Re: Consultation on an Application

Planning Application Ref: PL/26/0310

Address: 40-48 MOUNT PLEASANT, READING

Proposal: Retrospective demolition of car repair garages and erection of 6 dwellings (5 x 2-bed, 1 x 3-bed); with landscaping, waste storage areas, bicycle storage and associated works (an amended scheme to that approved under application reference PL/20/1880)

Below ground services block plan overlay: new tree conflicting with services

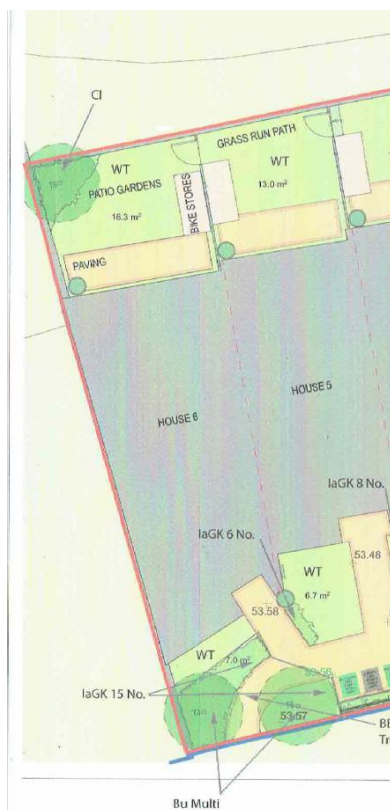
With reference to the Below ground services block plan overlay, Drawing No. 21, Rev P3, I note some of the services have been plotted, but not all. There is no clear sewage run and the extent of existing vs proposed services, is not clear. the southern tree on the frontage appears to conflict with the electricity route – clarity is required on how these are mutually inclusive. I don't note any access points such as that for inspections and repairs for the services demonstrated either.

Maintenance Plan (9. Planting Programme)

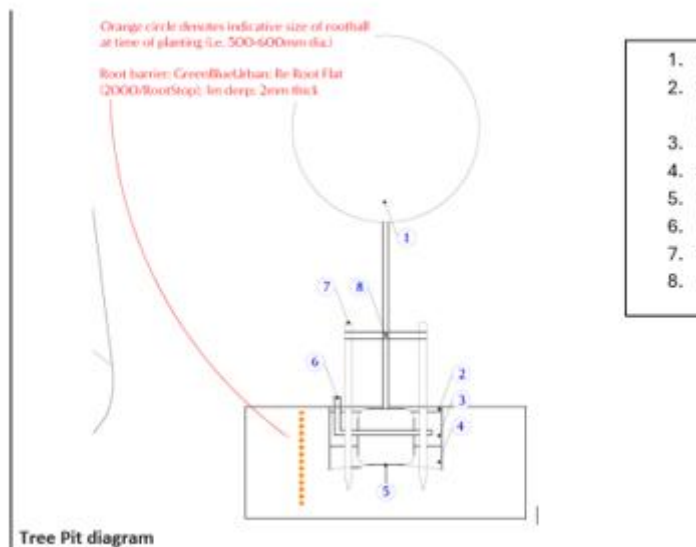
The Maintenance Plan has several inaccuracies and lacking information. The planting season is November-March, but this is not specified. There are several references to planting in September and late October, neither of which are in the planting season.

The Maintenance Plan does not go into enough detail to ensure successful establishment and appropriate maintenance. I am unclear who will take responsibility for the maintenance. Inspections are mentioned, albeit who will undertake the inspections?
